ADDENDUM NO. 3

August 7, 2026

MERRILLVILLE HS CULINARY AND MEETING AREA RENOVATIONS AND MERRILLVILLE CSC CENTRAL OFFICE ADDITION AND RENOVATION PROJECT

This Addendum consists of pages ADD 3-1 through ADD 3-2 and attached Addendum No. 3 from Gibraltar Design dated August 6, 2026, and consisting of 5 pages, Specification Section 10 11 00 - Markerboards and Corkboards, Specification Section 28 13 00 - Access Control System, and 22 Drawings.

AD101

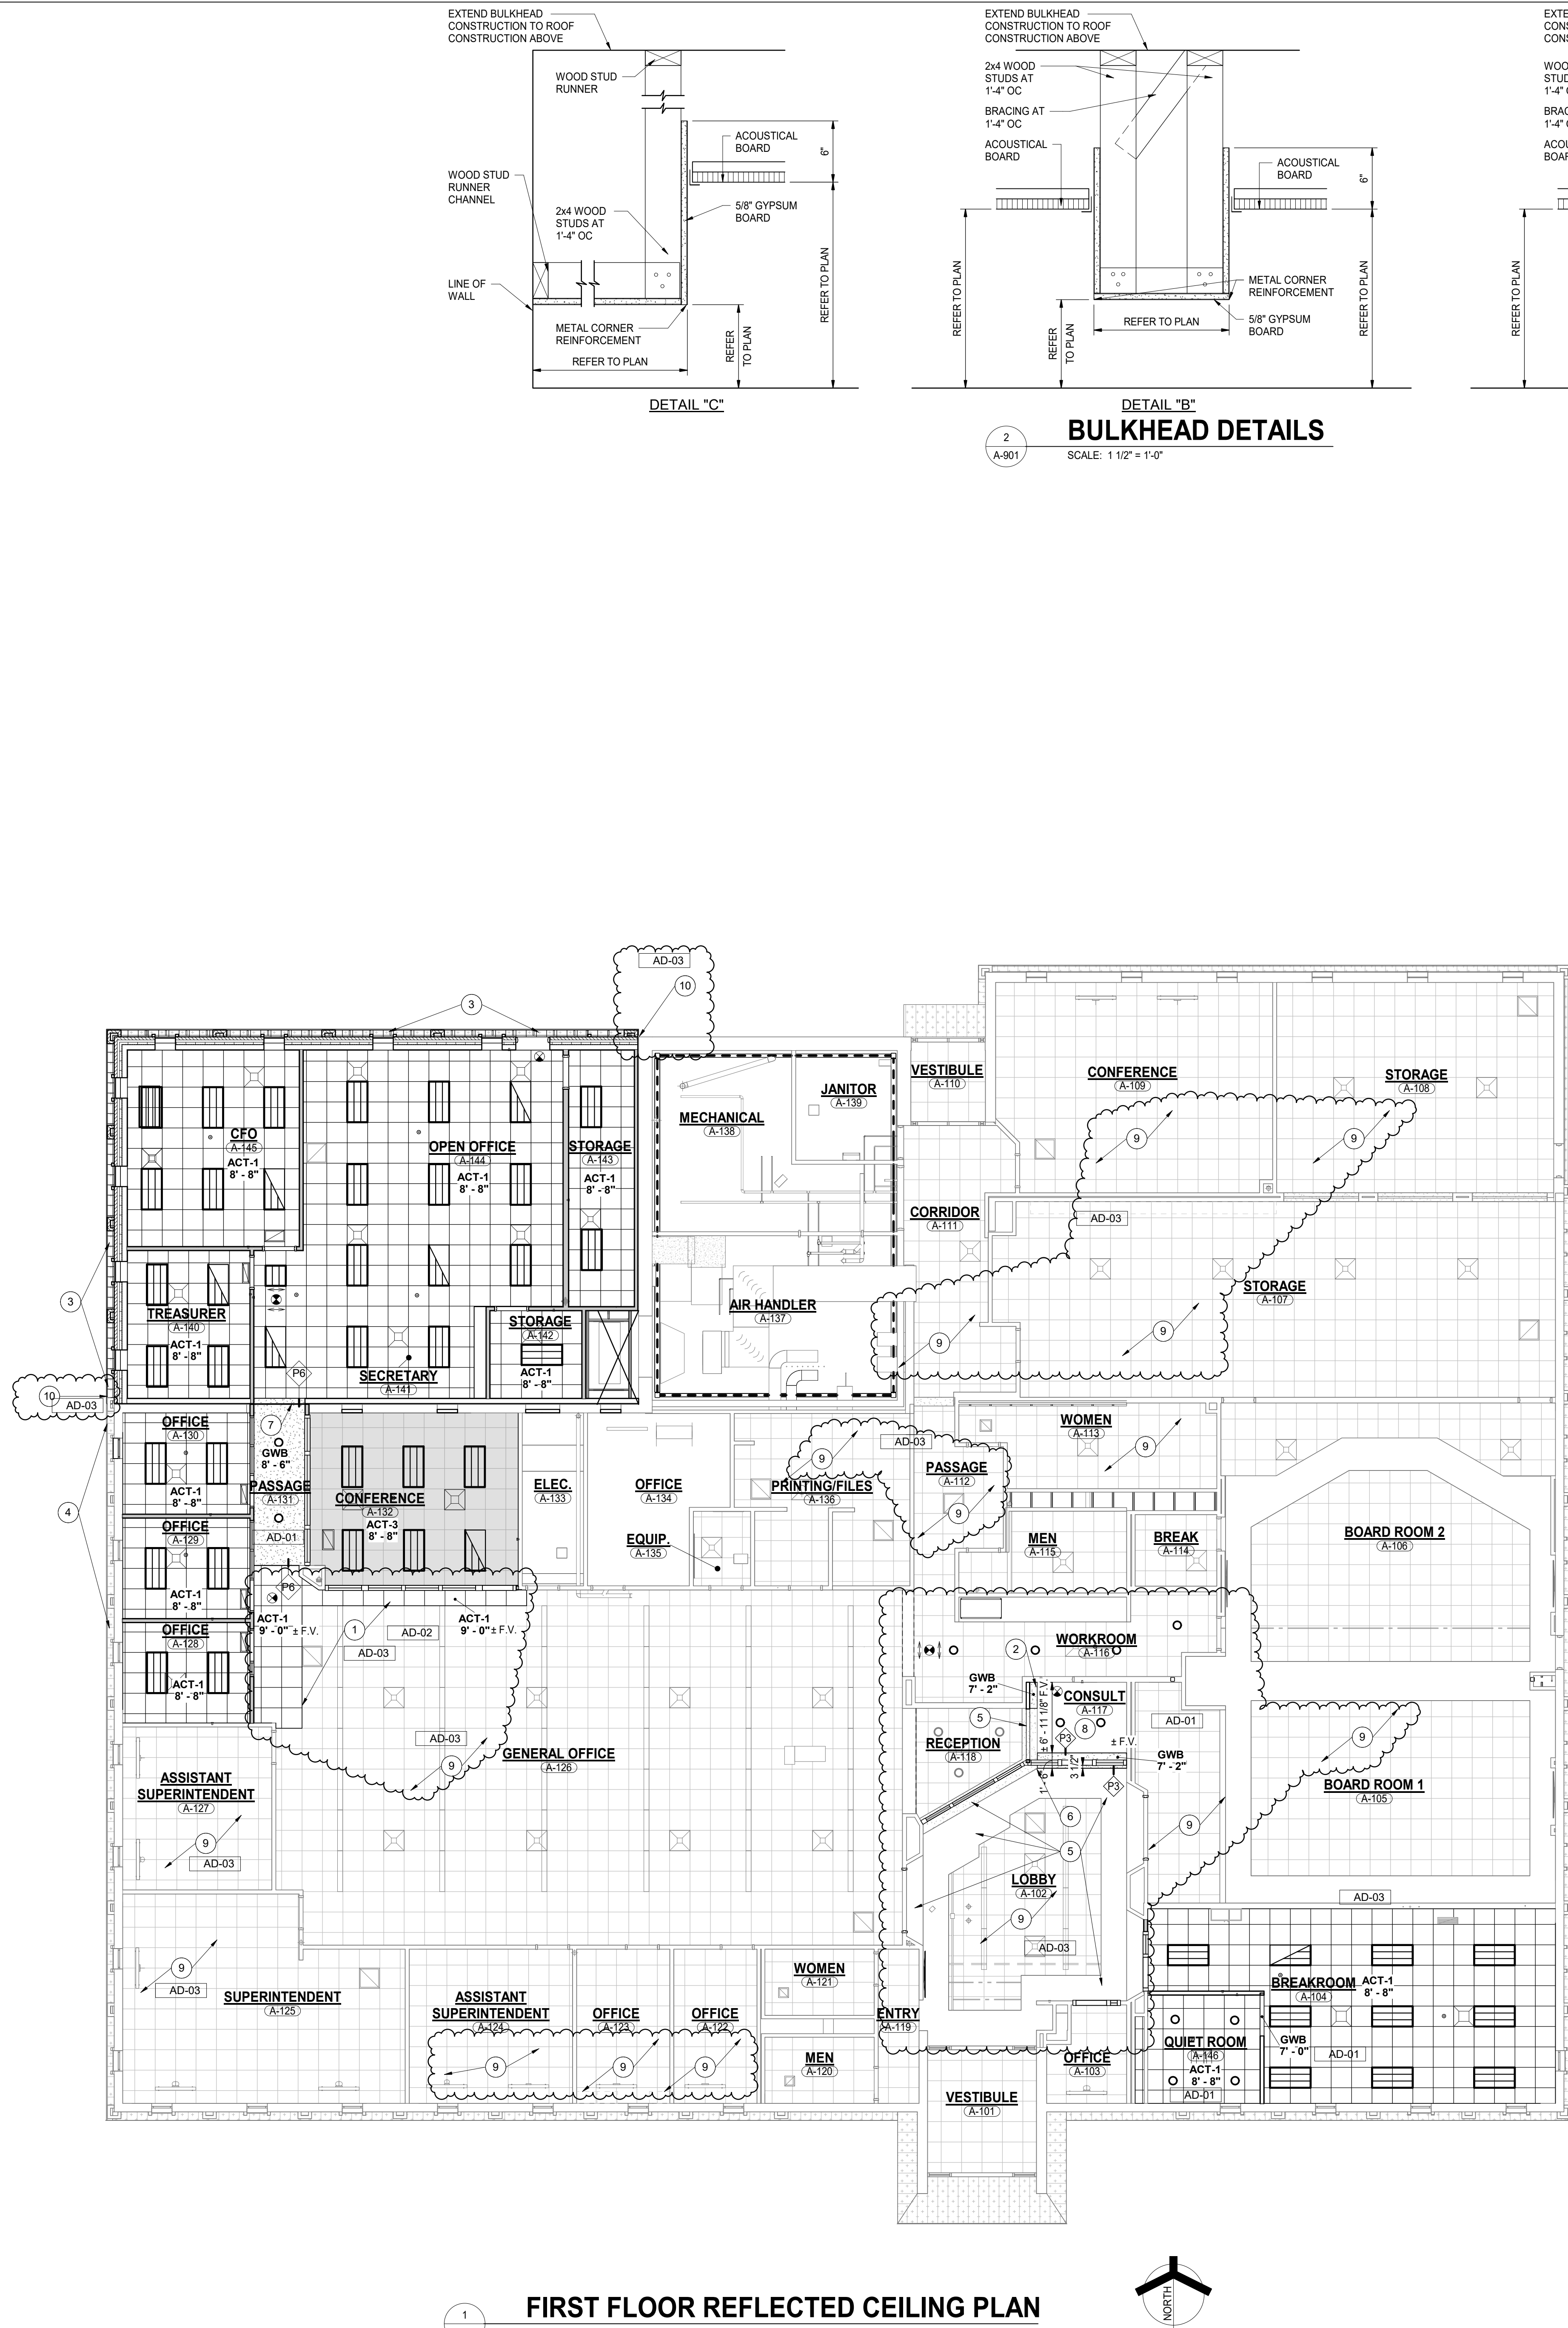
26. Sheet AD101

- A. Refer to revised, full-size drawing, included in this Addendum, for revisions.
 - 1. Revised plan note 19.
